SOUTHWEST INTERTIE PROJECT

FINAL ENVIRONMENTAL IMPACT STATEMENT and PROPOSED PLAN AMENDMENT

July 1993

COVER SHEET
Southwest Intertie Project
Final Environmental Impact Statement/Proposed Plan Amendment

CORRECTIONS TO: Panel 4 - Land Use Resources

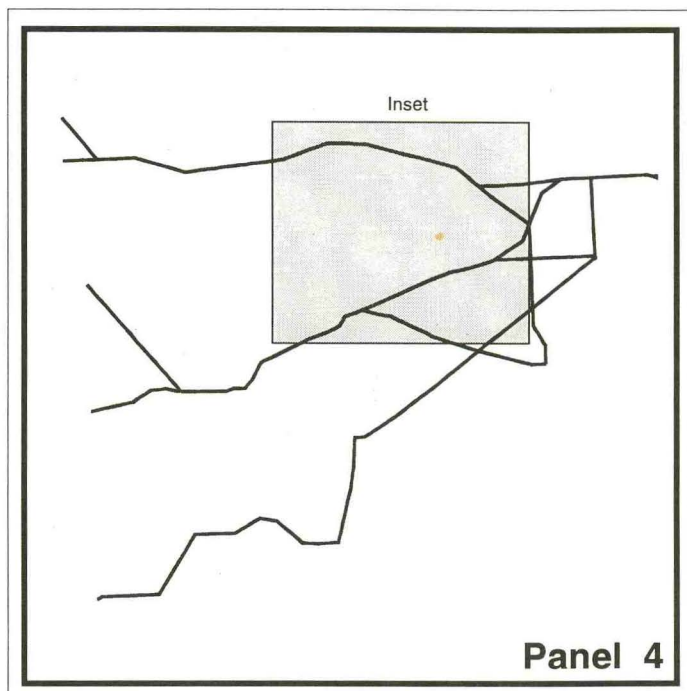
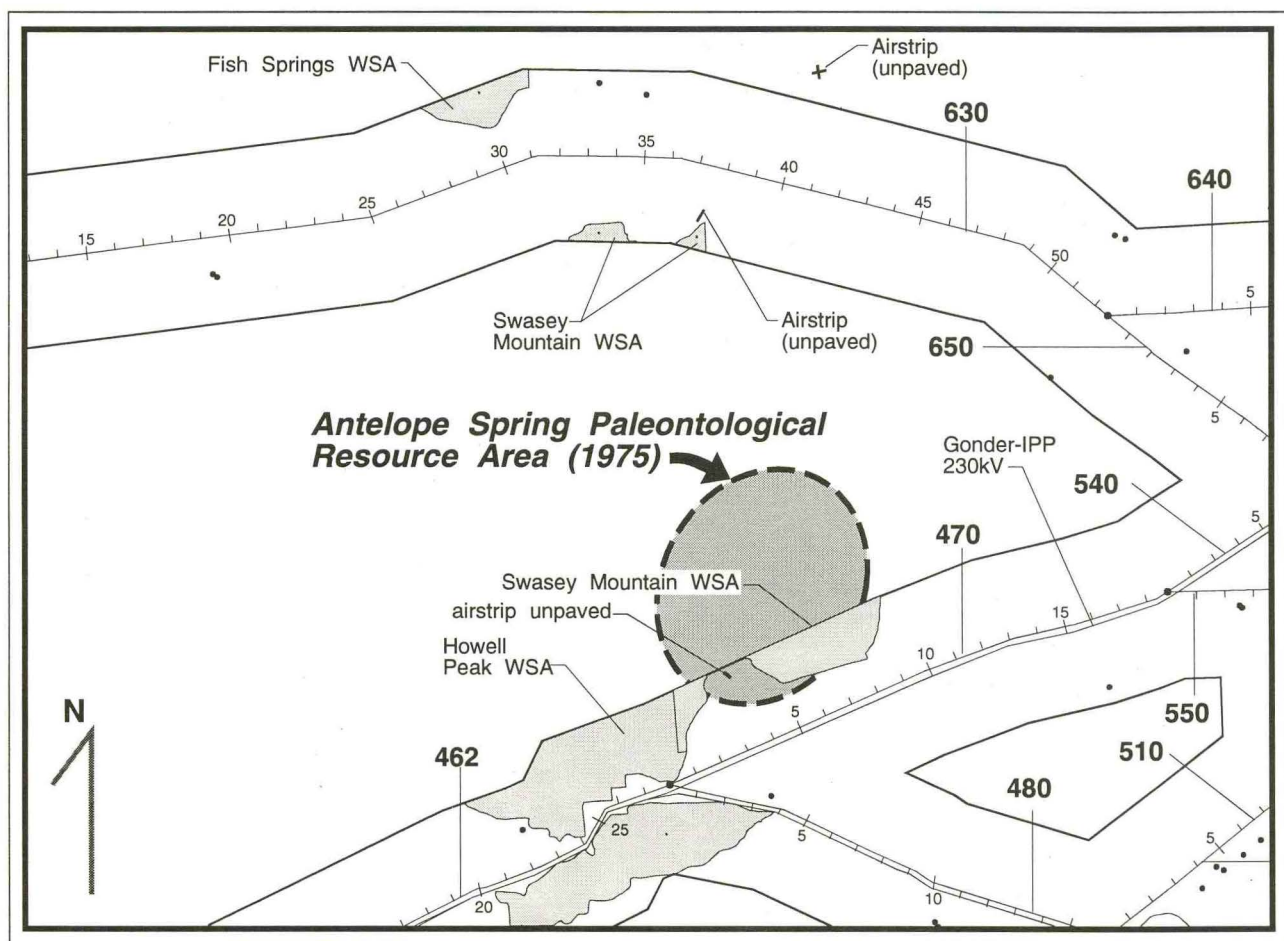
The Antelope Spring Trilobite Beds were not shown on the land use map in the Map Volume accompanying the DEIS/DPA. The boundary of this is illustrated below.

CORRECTIONS TO: Panel 5 - Land Use Resources

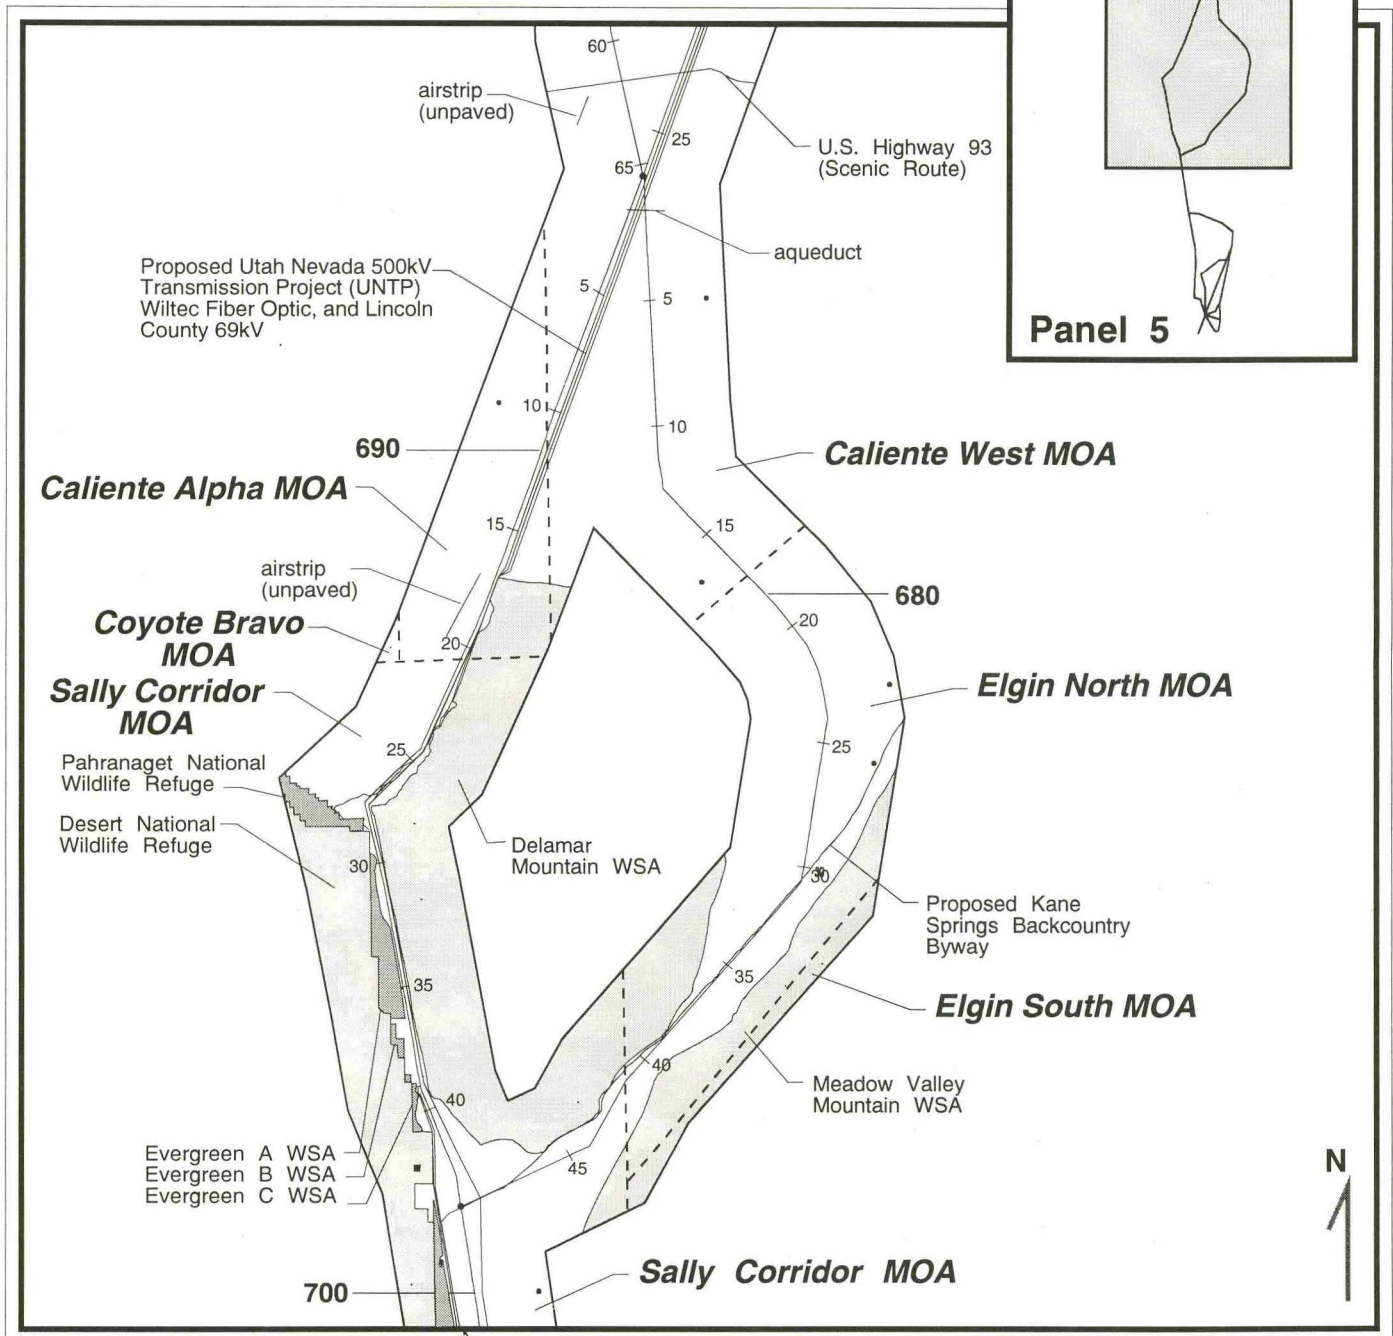
The labels identifying MOAs are missing on this map. These additional labels are illustrated below.

Panel 5 - Land Use Resources

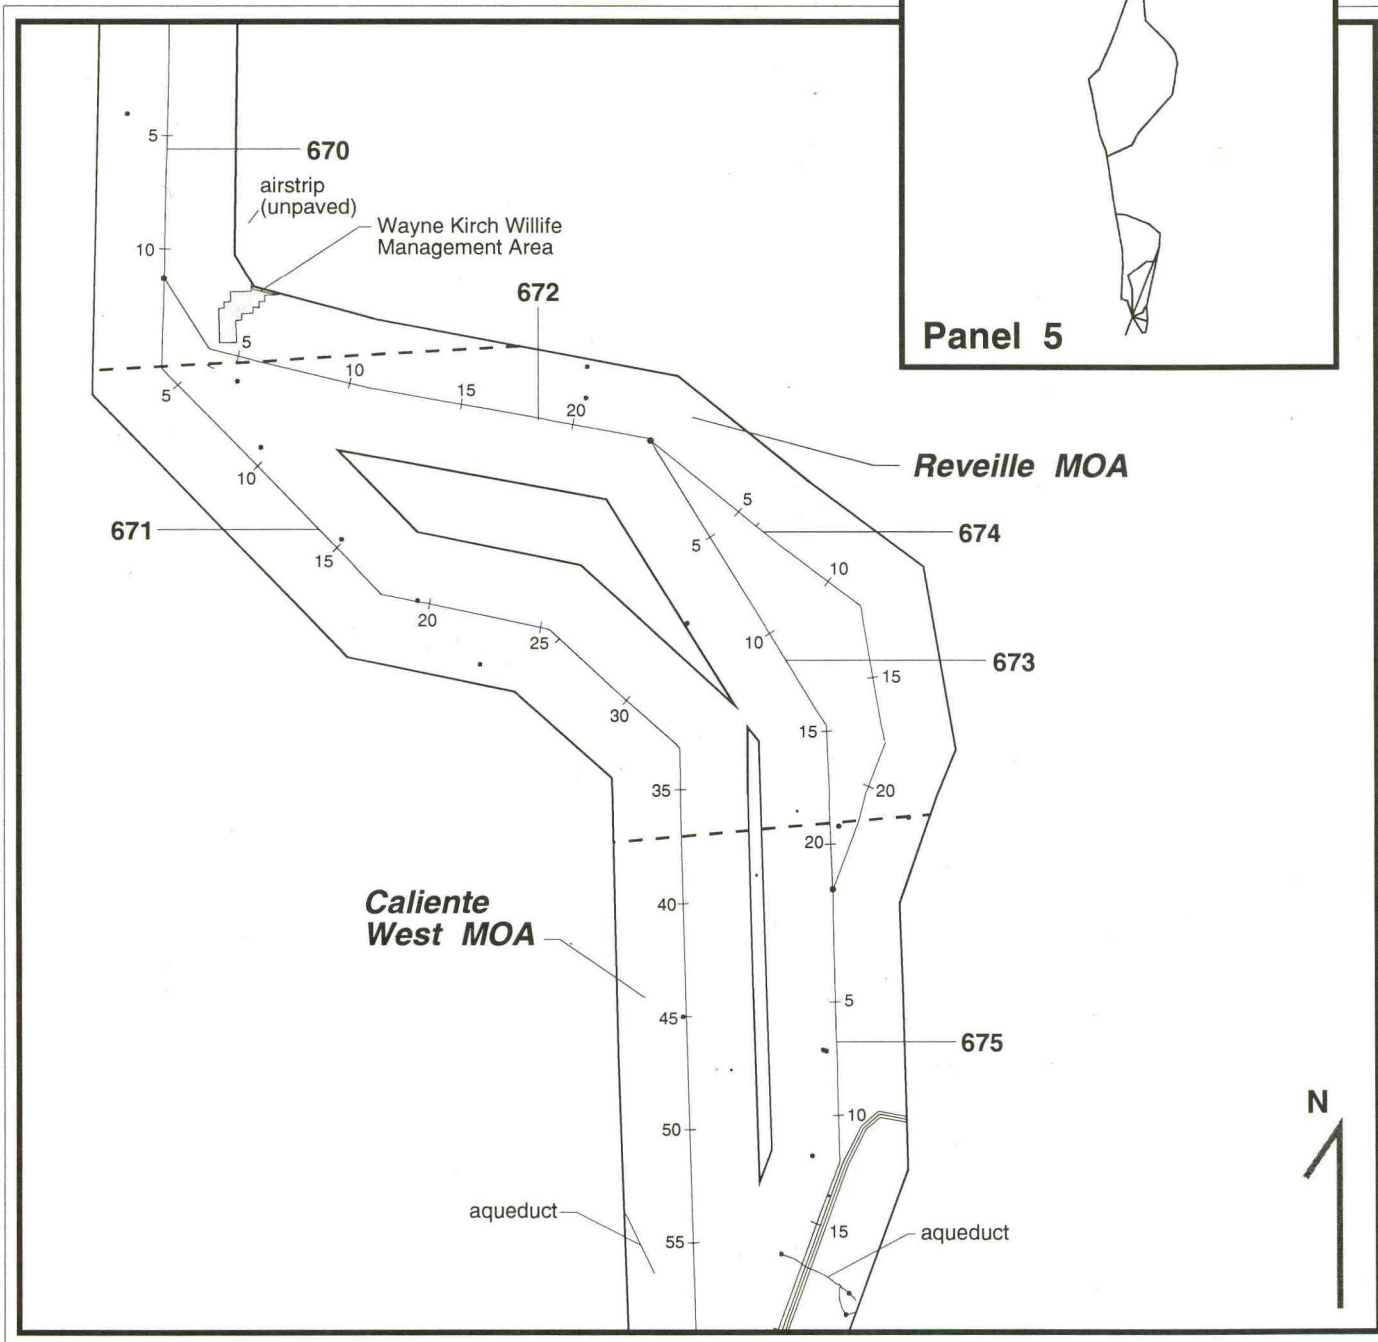
The labels identifying MOAs are missing on this map. These labels are illustrated below.

CORRECTIONS TO: Panel 4 - Jurisdiction

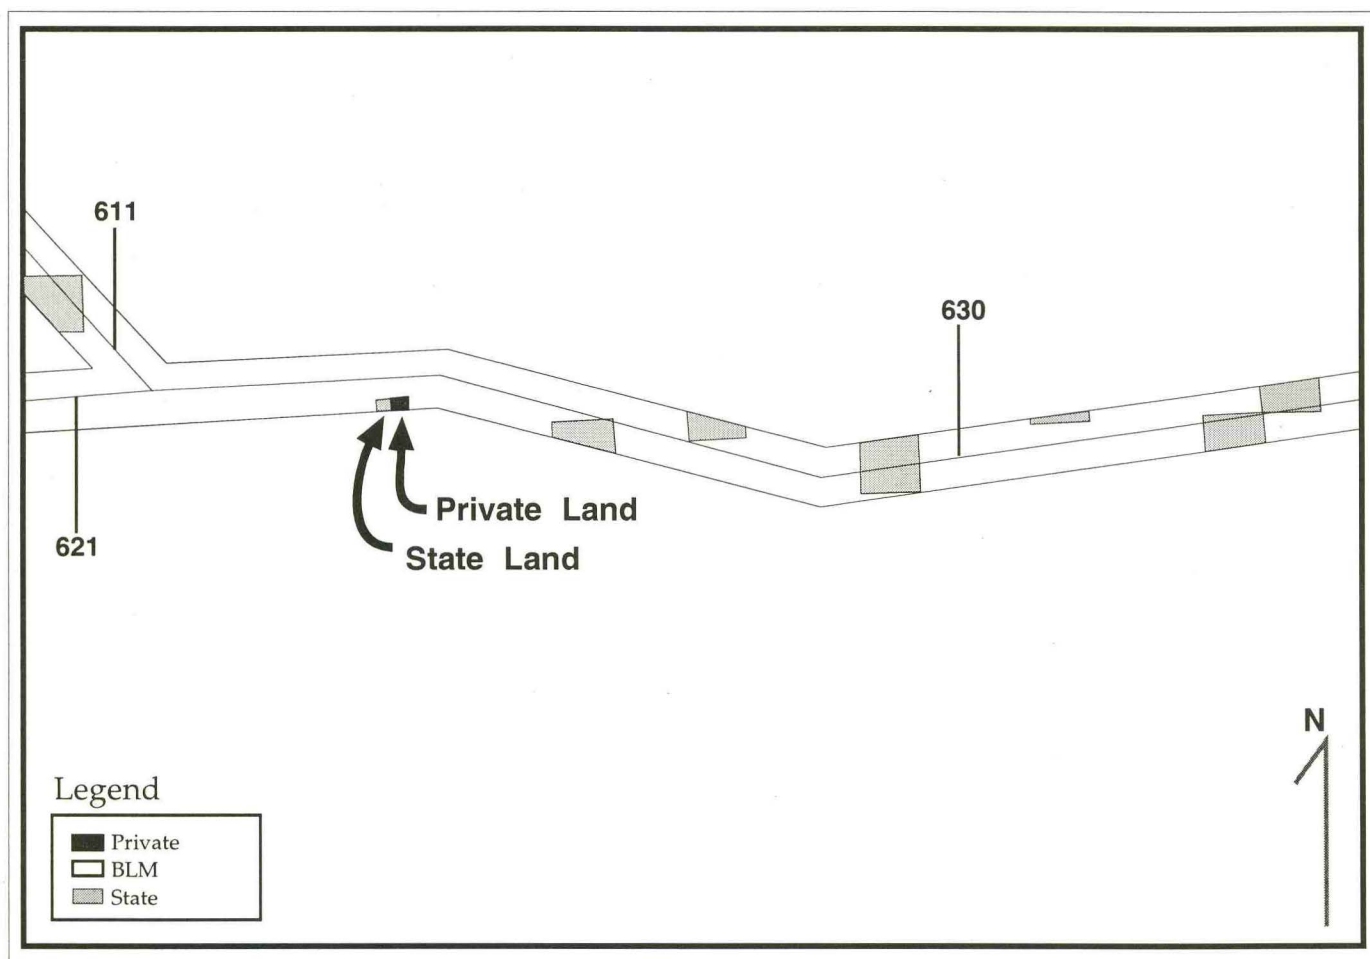
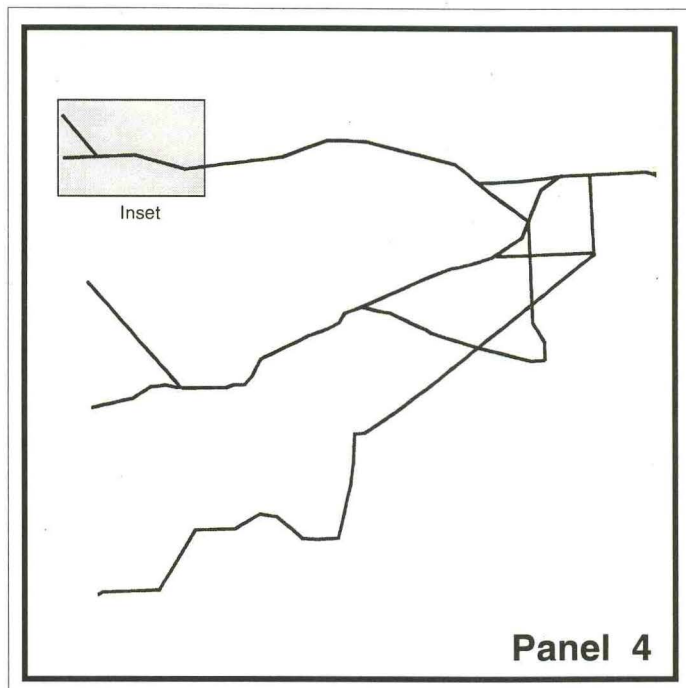
A small area of State Land at T14S, R18W, Section 28, NW1/4 SW1/4 and a small area of private land at T14S, R18W, Section 28, NE1/4 SW1/4, S1/2 SW1/4 were missing on this map. These lands are illustrated in the map below.

CORRECTIONS TO: Panel 2 - Visual Resources

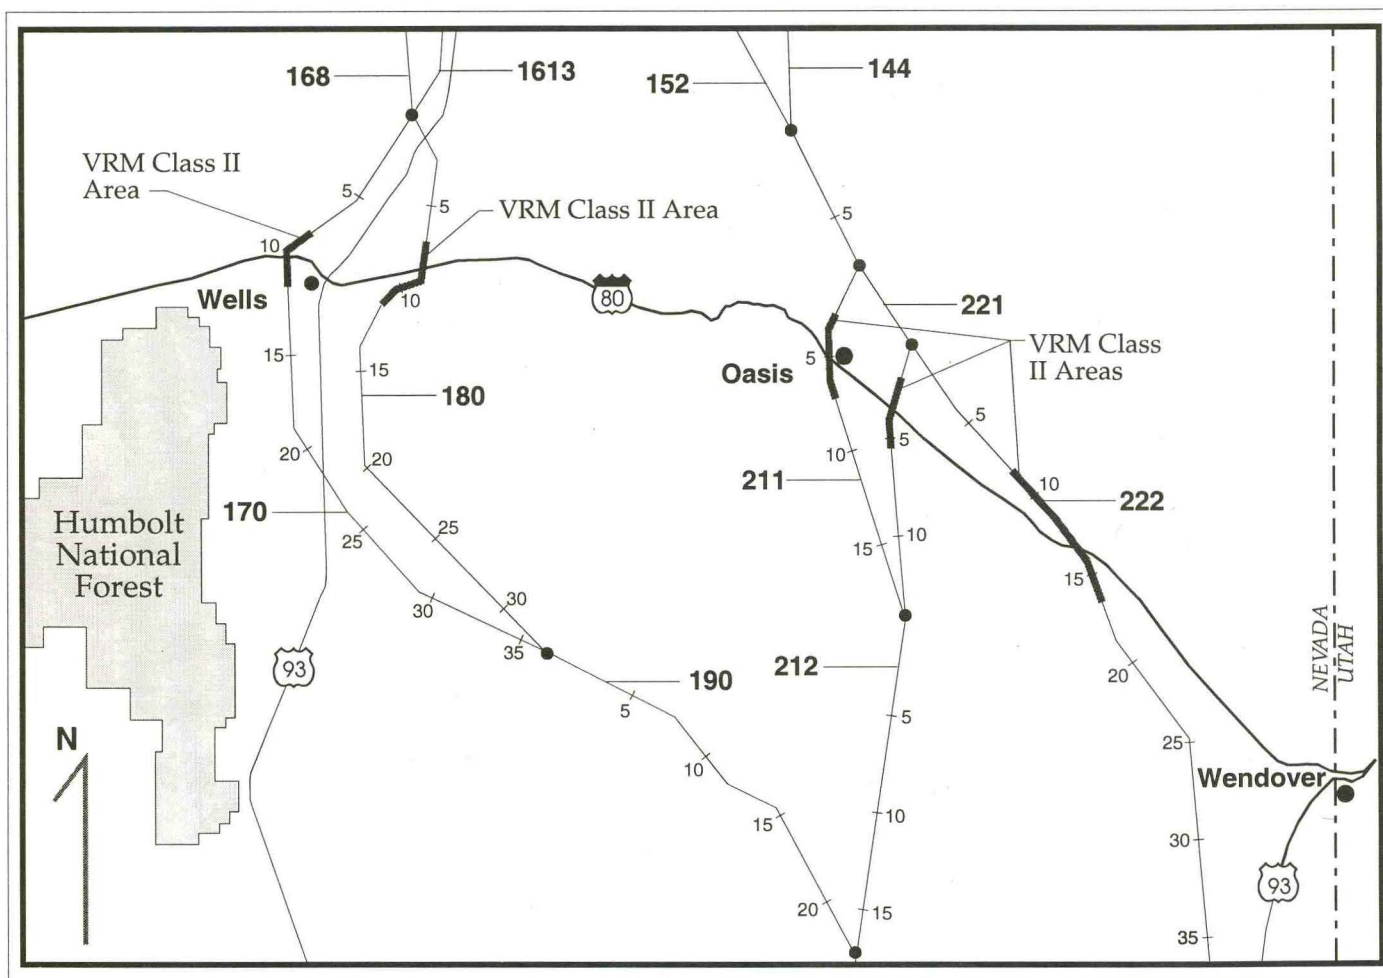
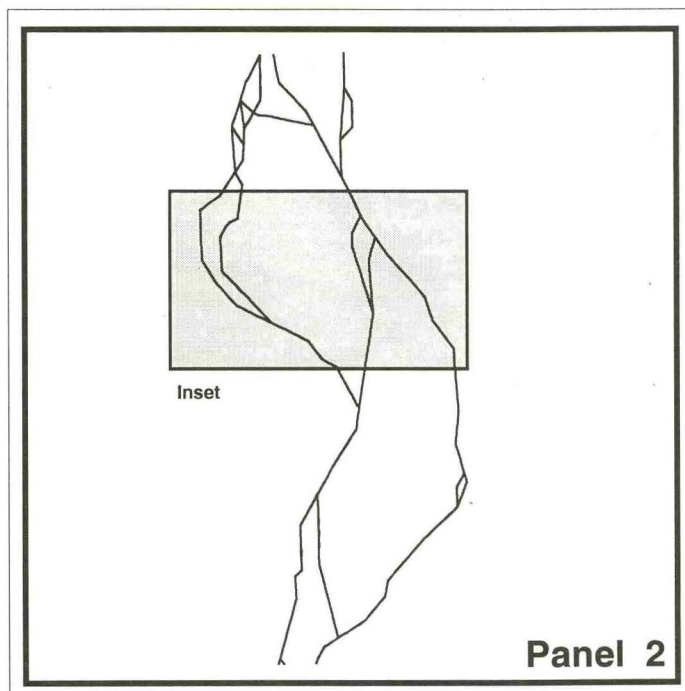
- Panel 2 - Visual Resources:** The BLM low visibility corridor around Interstate 80 did not appear on the map. The VRM Class II area is shown in Figure 4-11.

This map shows the portion of the alternatives that would cross VRM Class II in the Wells District (Interstate 80 low-visibility corridor).

CORRECTIONS TO: Panel 3 - All Resource Maps

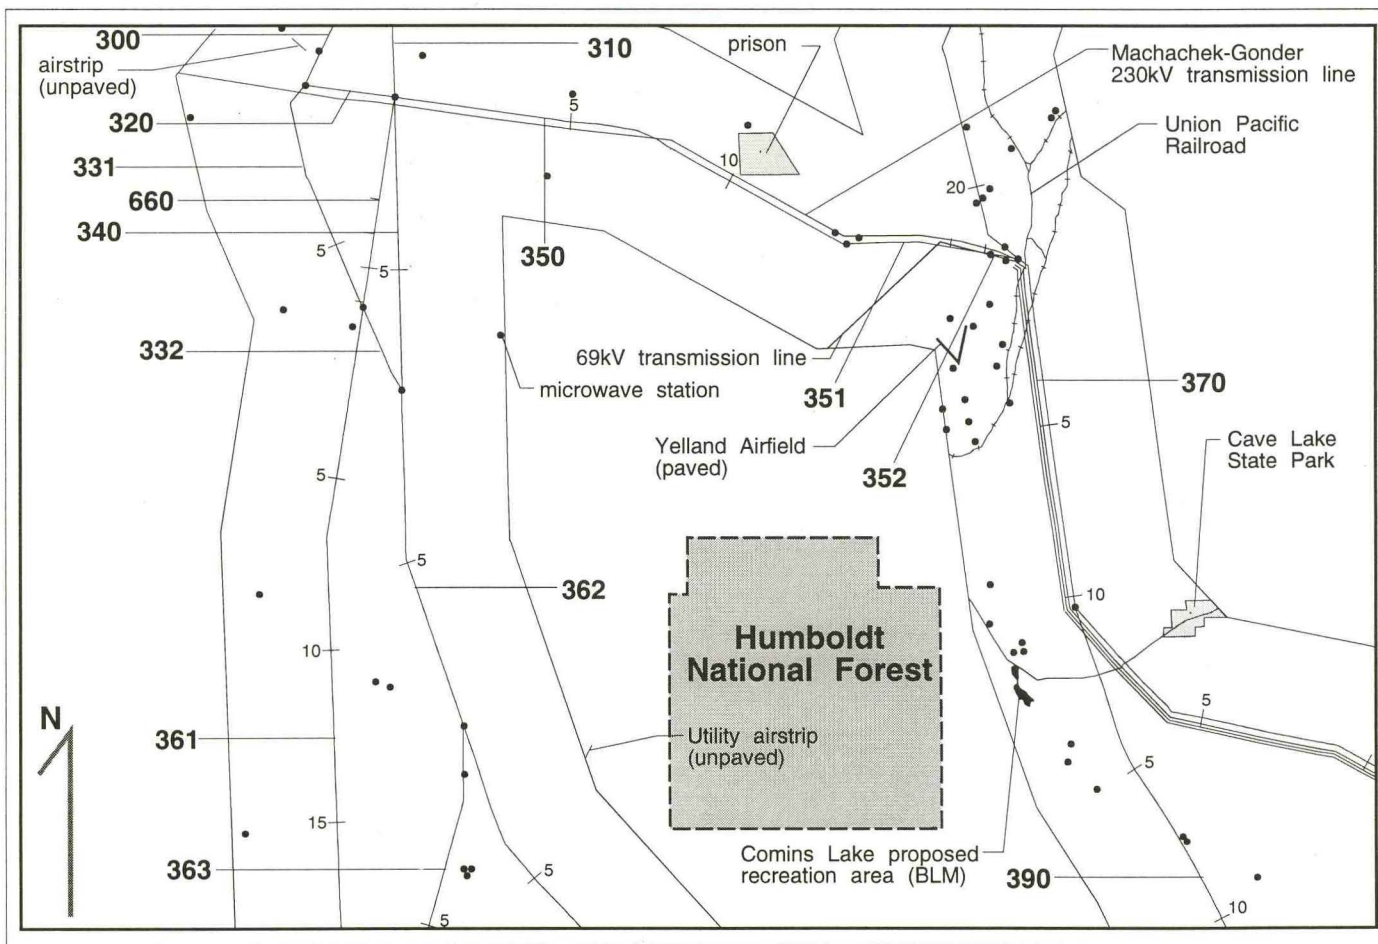
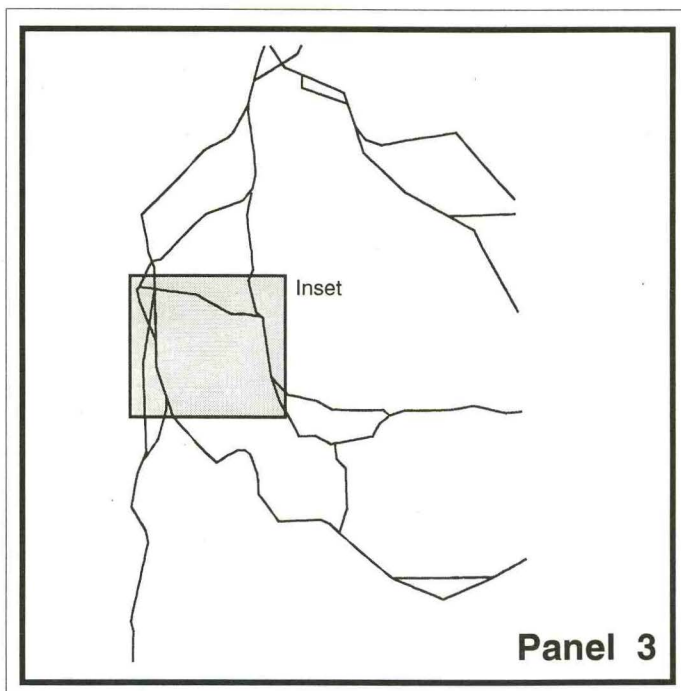
- Panel 3 - All Maps:** The boundary of the Humboldt National Forest South of Ely was left off of all the Panel 3 Maps. Figure 4-12 shows the approximate location of the boundary.

All Panel 3 maps are missing the Humboldt National Forest Boundary for the area south of Ely. The boundary is illustrated below.
